ALB ALBANY INTERNATIONAL AIRPORT

Minutes of the Regular Meeting of the Albany County Airport Authority
October 13, 2026

11. Authorization of Change Orders

11.1 Change Order 16: Authorization to Award Contract Change Order No. 16 to Construction Contract 21-1082-INT STR for the Pre-TSA Terminal Expansion to MLB Construction Services, LLC.

E-101

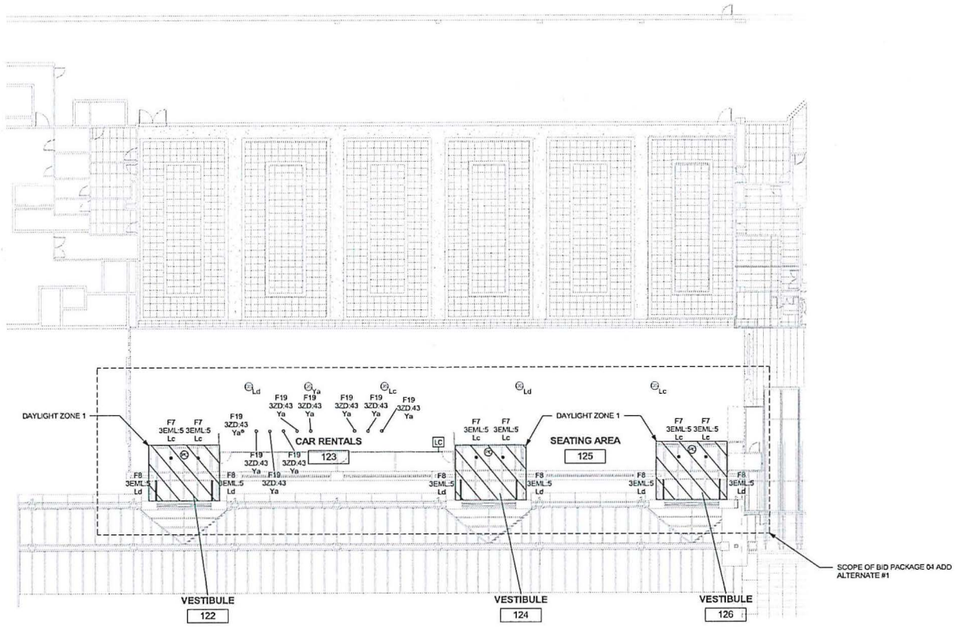
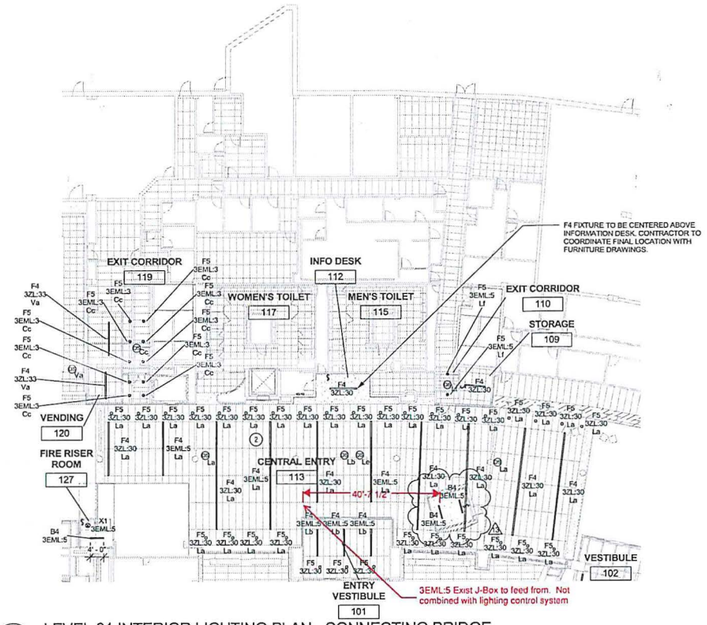
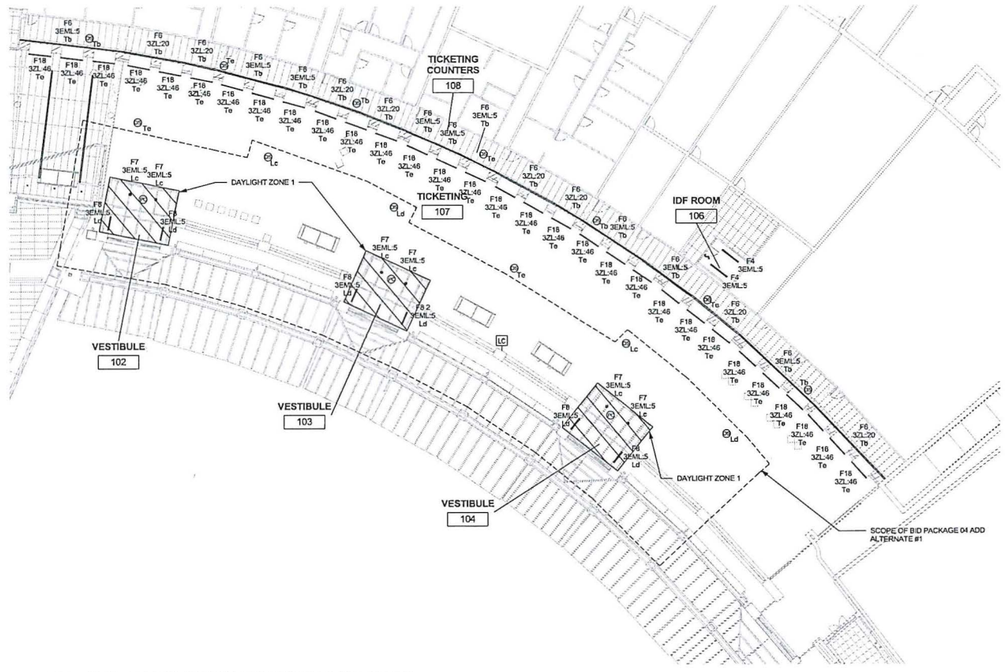
2. Dwg E-101 –
   - No work was ever priced for said relocations to Escalator Machine Room 128 as this relocation was overcome by events/RFI's/ACAA decision to keep existing L1 Panels and create a new Electric Room.
   - Delete conduit/circuit rough-in for floor box. The already purchased floor box cover will be turned over to ACAA.
3. Dwg E-201 - Added 2-Type B4 Lights and 1-single pole toggle switch
4. Dwg FA-101 - Added 1-Smoke Detector, 1-Wall Mtd Speaker Strobe, & 1- Ceiling Mtd Speaker Strobe.

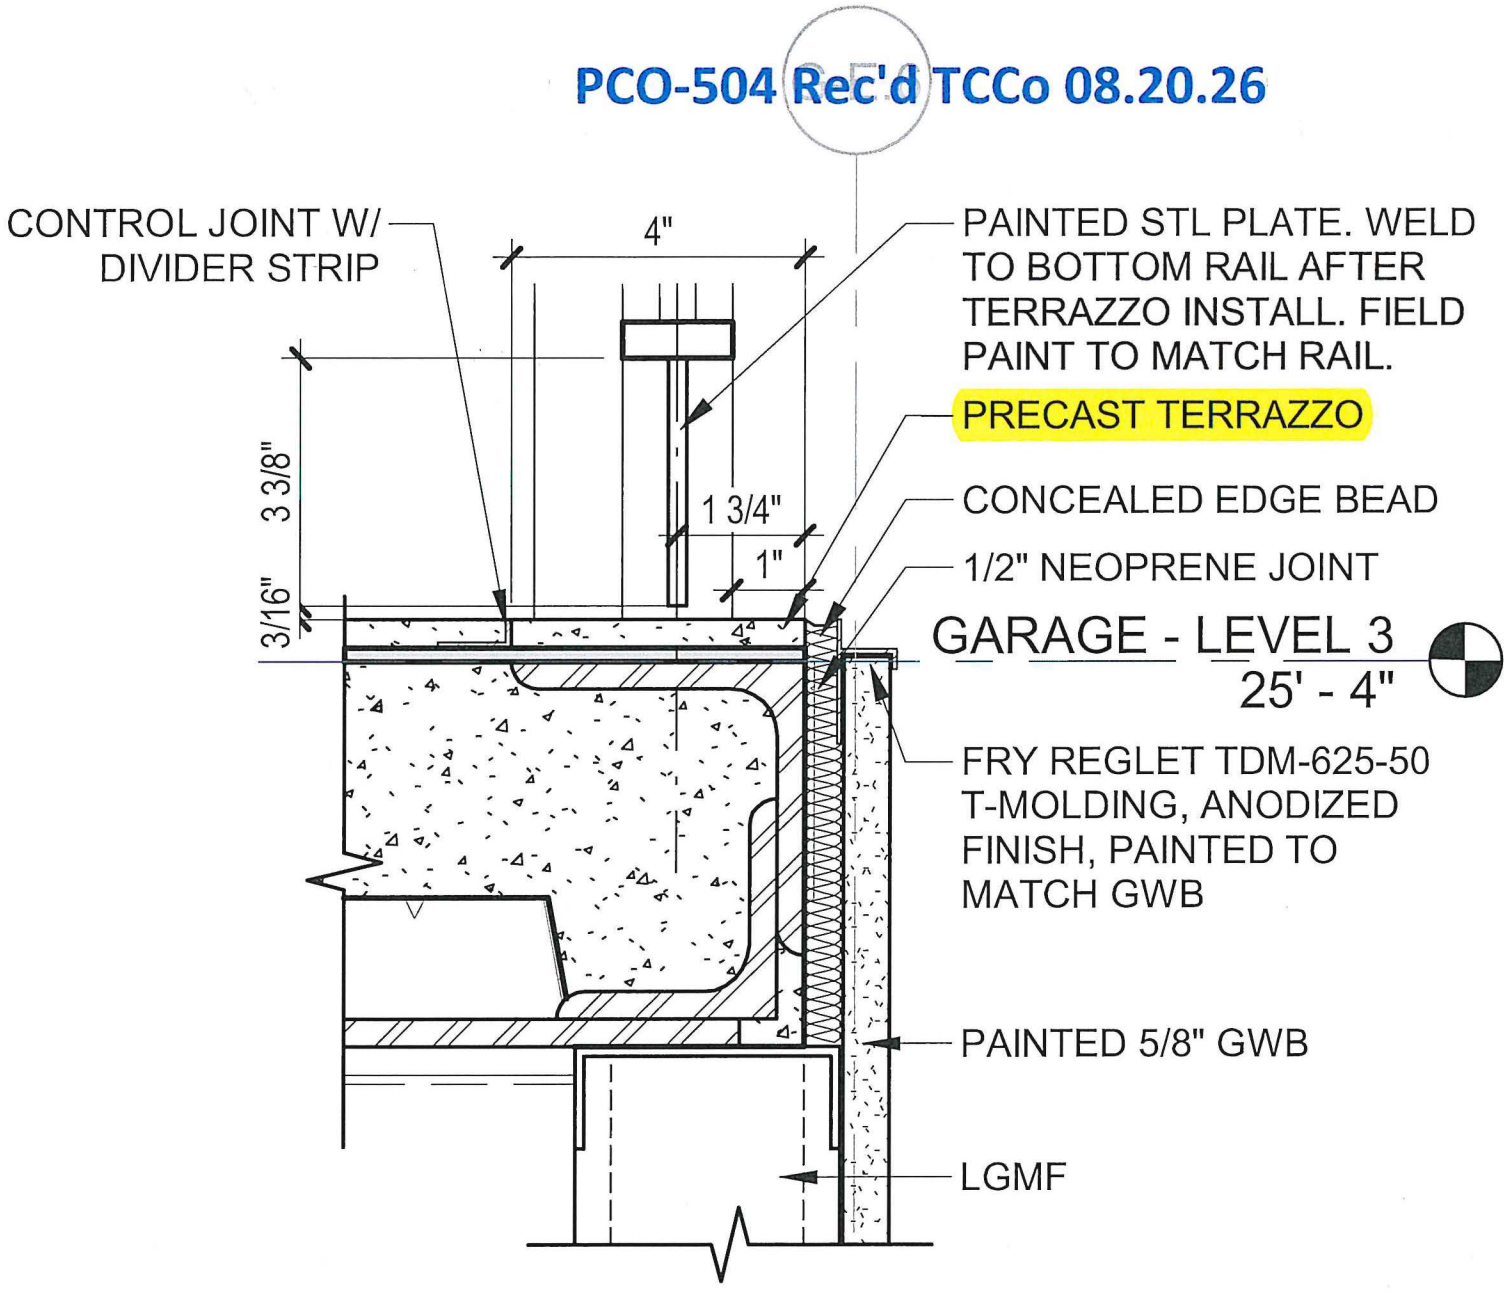
A.) Section C2/A-409 identifies the vertical posts of the handrails to be set in concrete with epoxy fill. However, detail D3/A-409 further clarifies that the structural design includes a double angle slab edge. The question was posed if LERA is aware of the amount of cores that would be done through this top angle and the group agreed that is probably not acceptable. CHA is confirming with LERA that this needs to be a welded connection to the top of the upper angle.

A. Do not core through installed angles. Weld vertical railing posts to angles as proposed. Refer to attached revised detail D3/A-409 for typical floor finish at edge of slab.

B. Building code does not require a toe kick. Airport Authority prefers toe kicks for safety considerations. Refer to attached revised detail D3/A-409 for typical toe kick.
